Ohio Museum Complex HVAC  
Lin Hall, The Ridges – Ohio University  
Athens, Ohio

## ADDENDUM 01 - REBID

Addendum to the drawings and specifications for: **Ohio Museum Complex HVAC**

SHEET  
**E3**

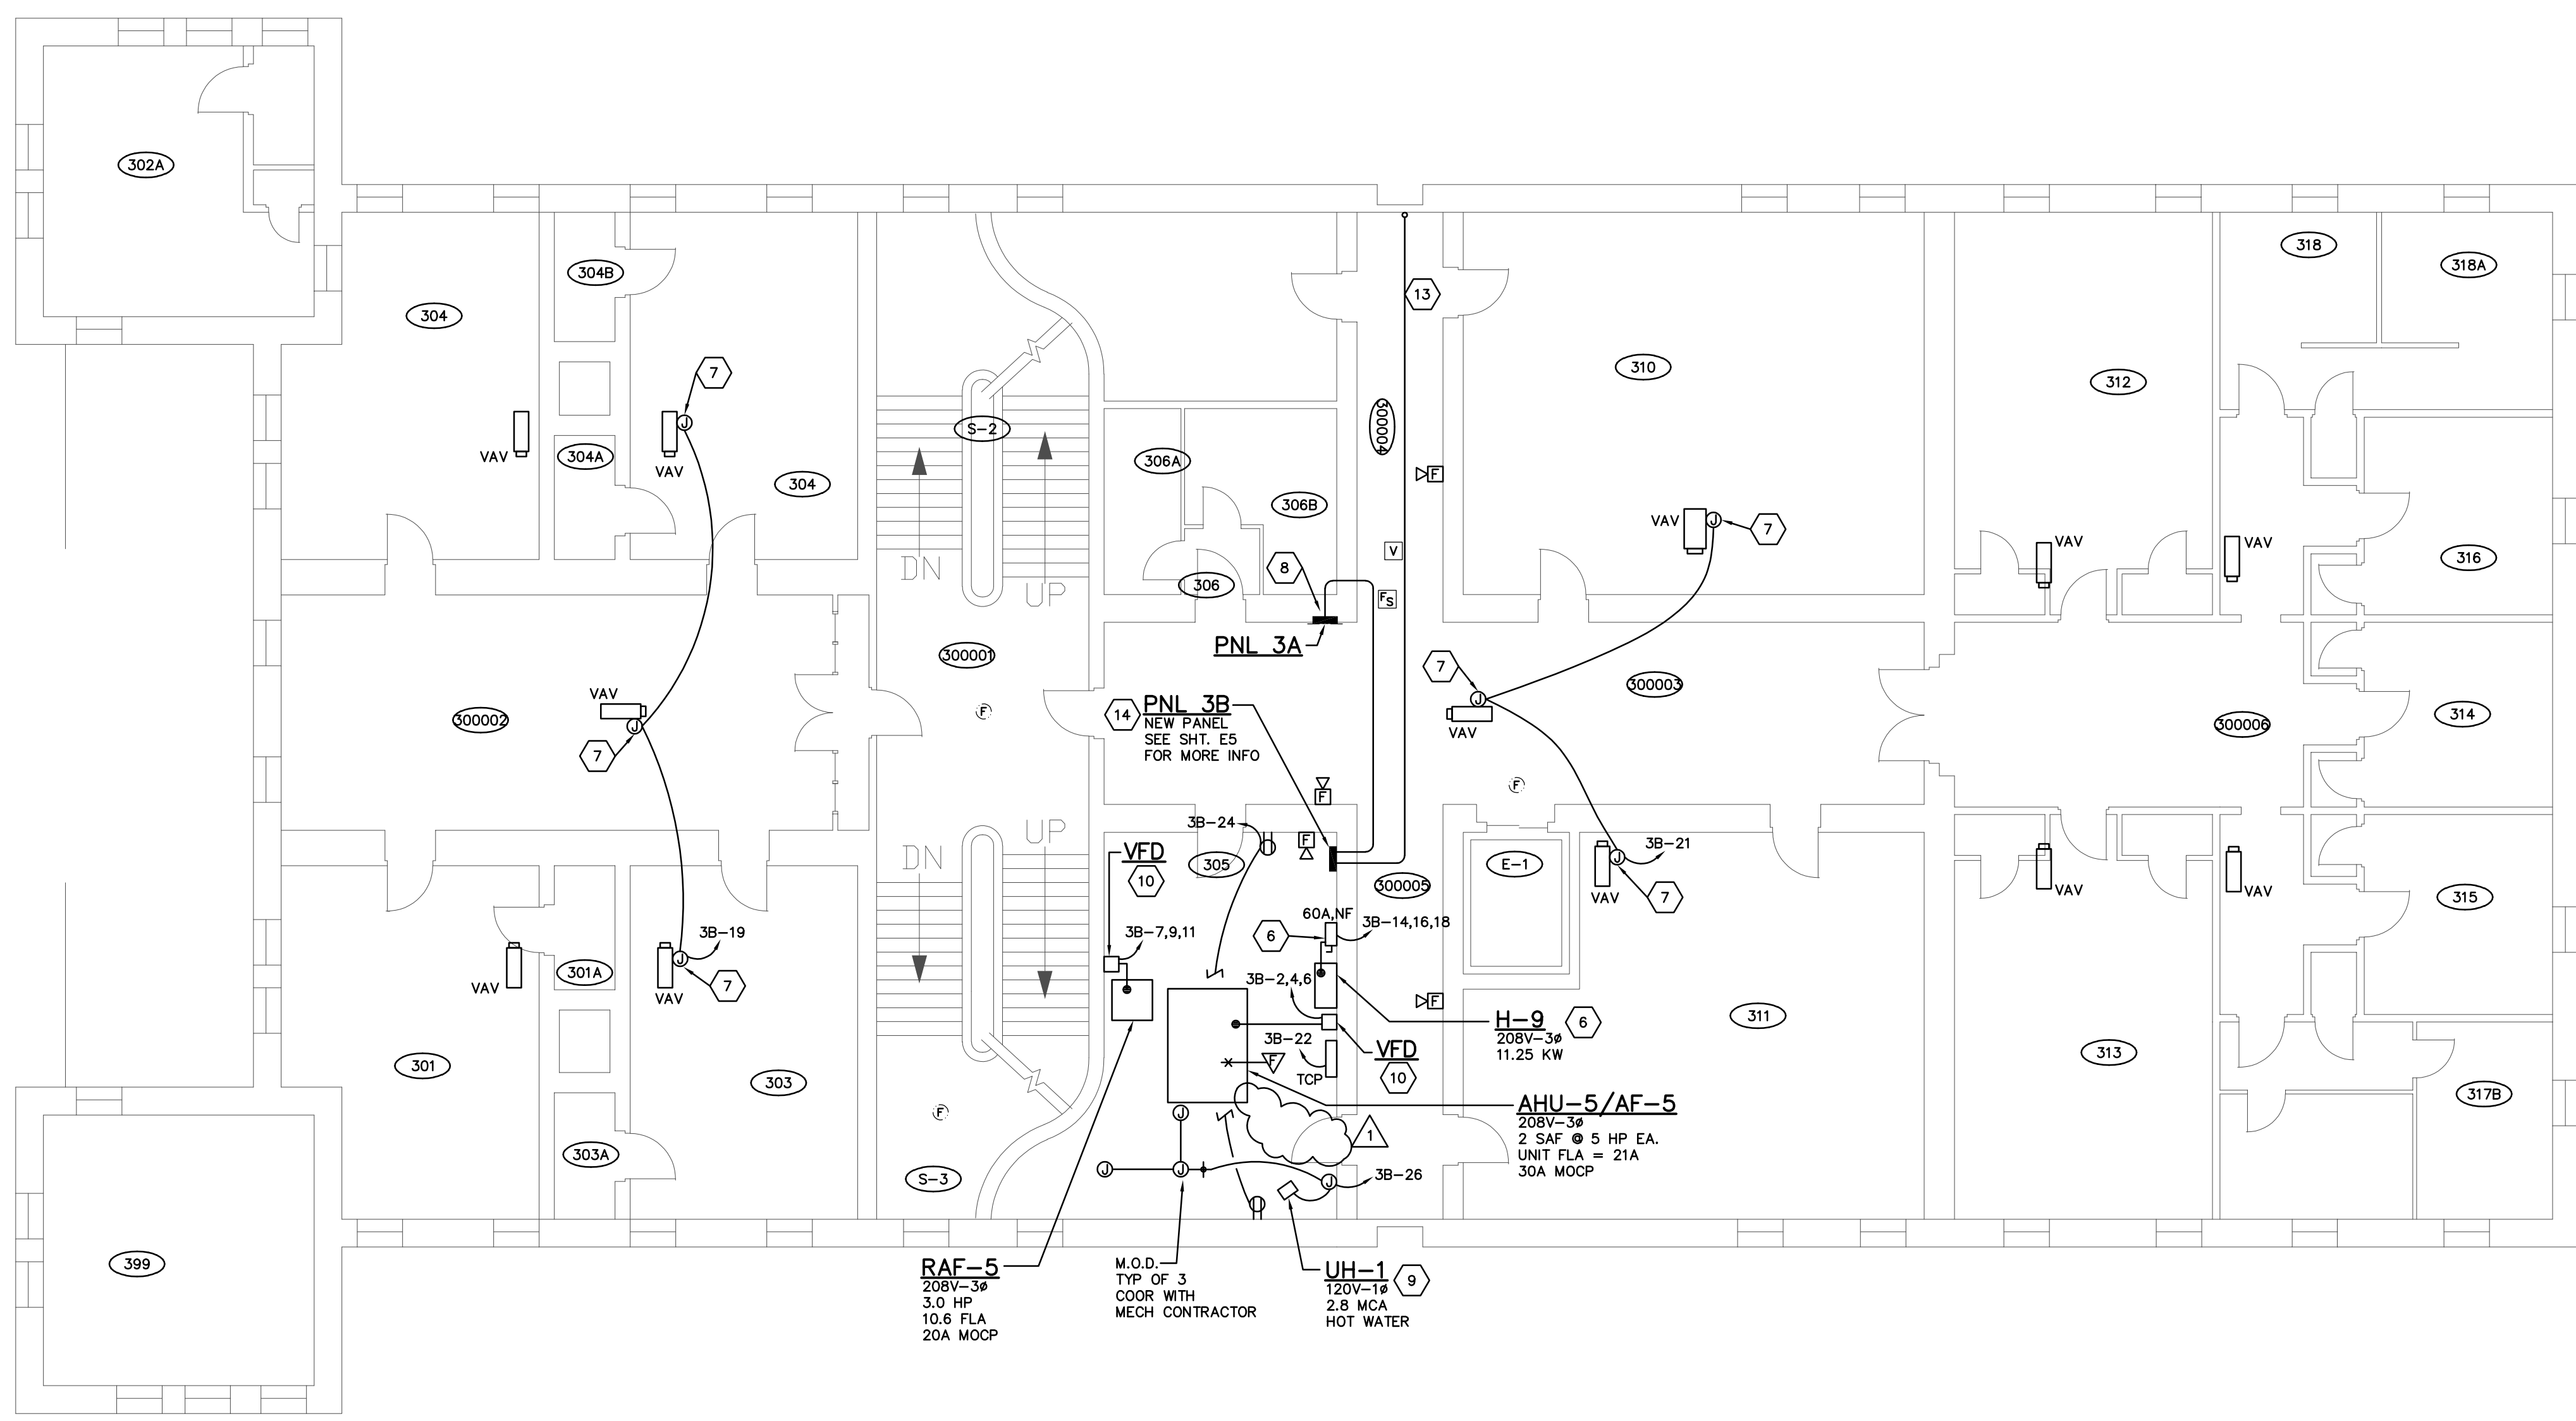
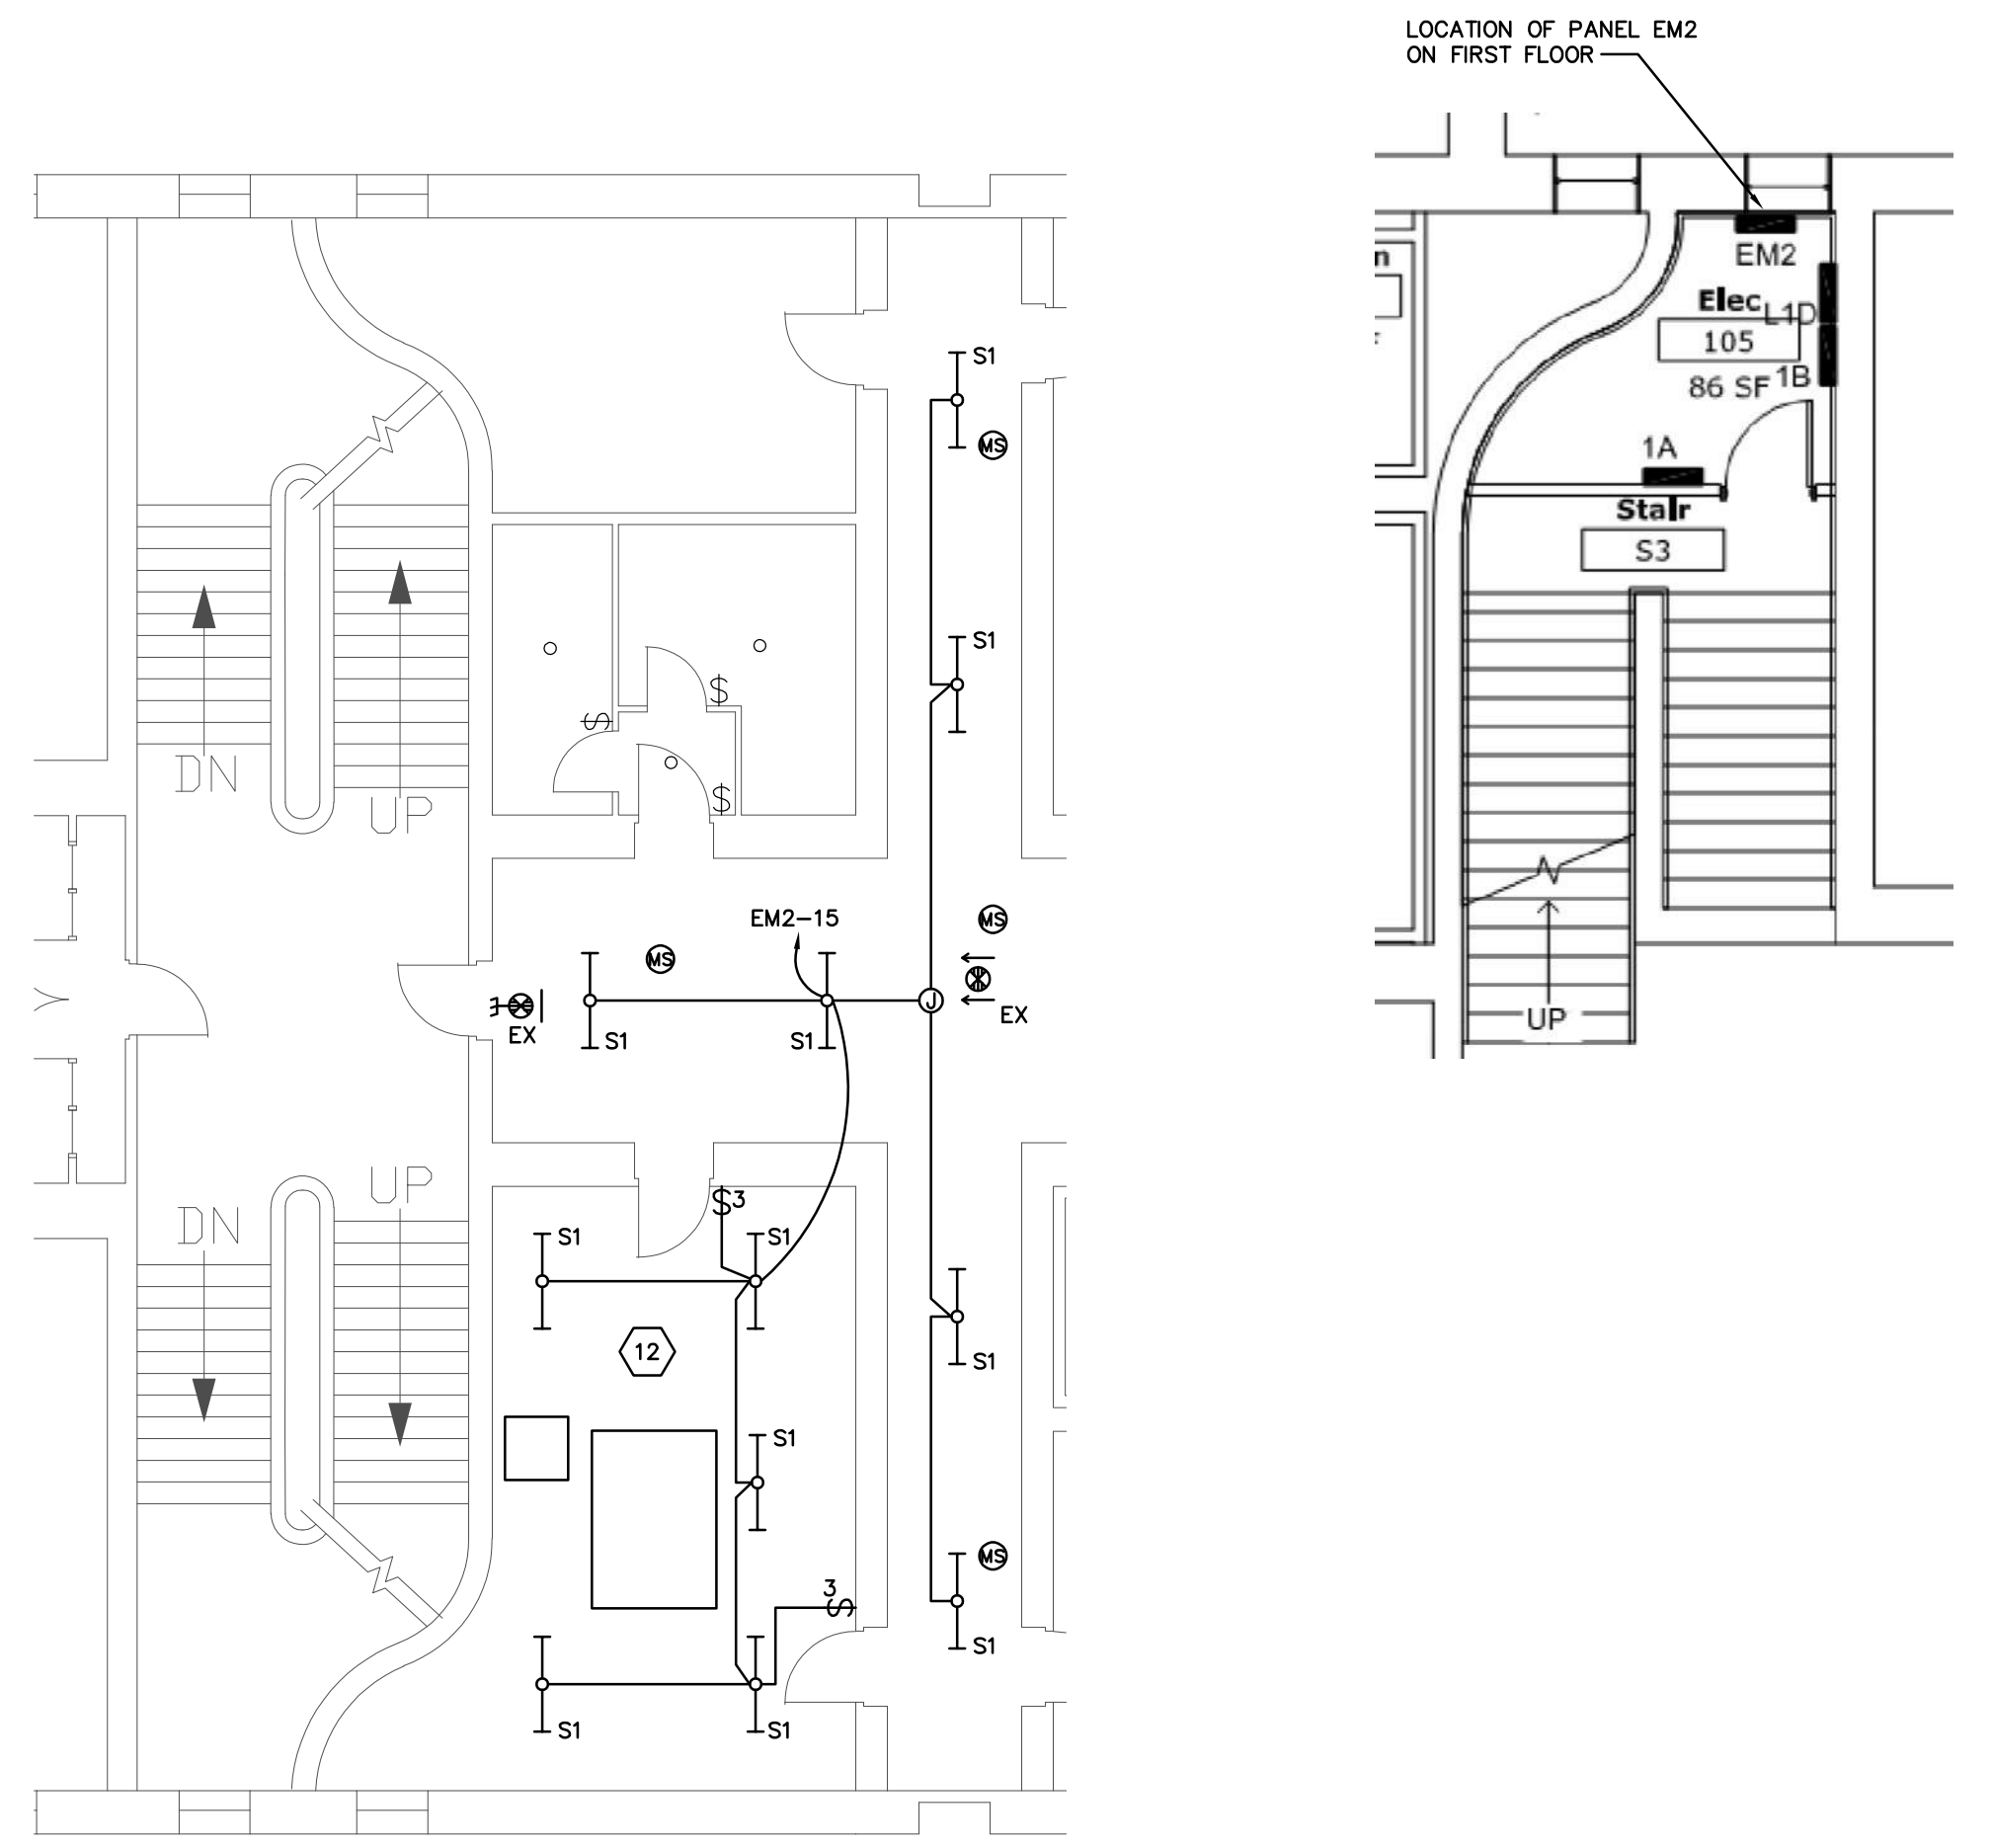
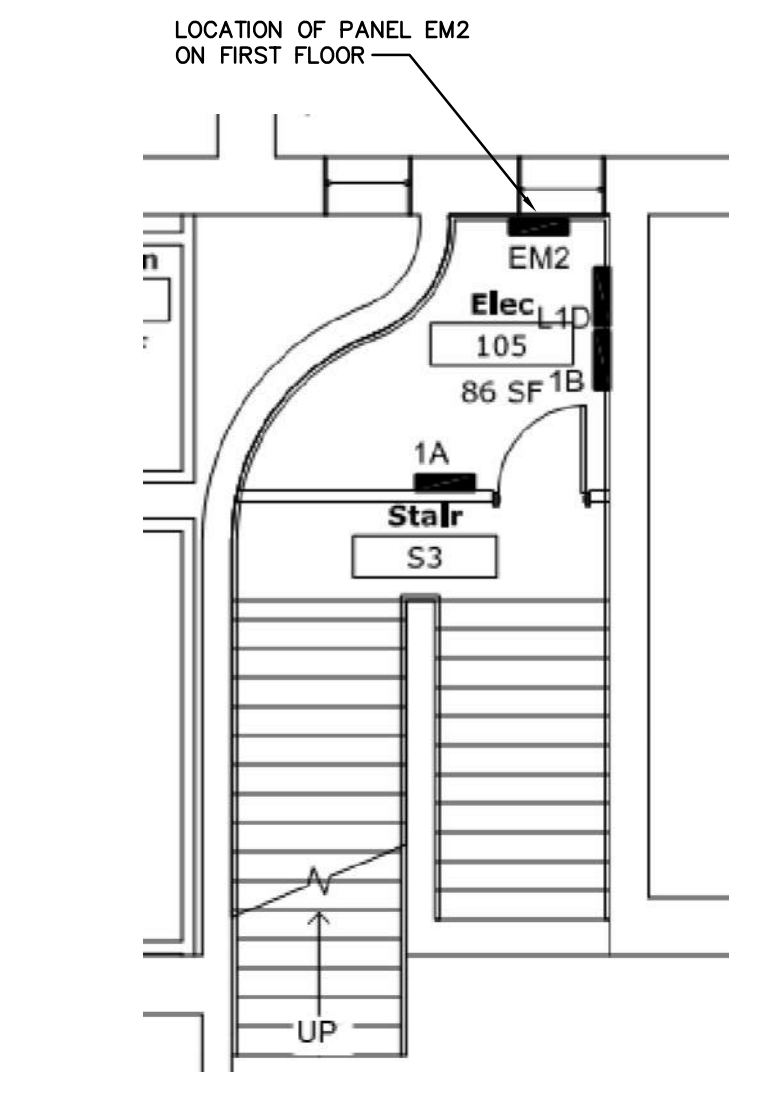
1. Revised Sheet H6 attached is to replace previously issued sheet.
2. Revised Sheet E3 attached is to replace previously issued sheet. Removed air filter, and associated circuit and coded notes 15; updated coded notes 7.
3. Revised Sheet E4 attached is to replace previously issued sheet. Removed air filter, and associated circuit and coded notes 12; updated coded notes 7
4. Revised Sheet E5 attached is to replace previously issued sheet. Updated feeder for Panel 3A on One Line Diagram; updated coded notes no. 11.
5. Revised Sheet E6 attached is to replace previously issued sheet. Deleted Starter Schedule; updated panel schedules for Panel 2B, 3B and 4B.

- DELETED.

- 7. PROVIDE 120V, 20A CIRCUIT AT EACH LOCATION SHOWN WITH A C-BOX (LINK TO SEE LOCATIONS) FOR VAV CONTROLS. REFER TRANSPORT AND WIRING FURNISHED BY MECH CONTRACTOR. COORDINATE EXACT LOCATIONS FOR WHERE 120V CIRCUITS ARE NEEDED WITH T.C.C. IN FIELD PRIOR TO ROUGH-IN.
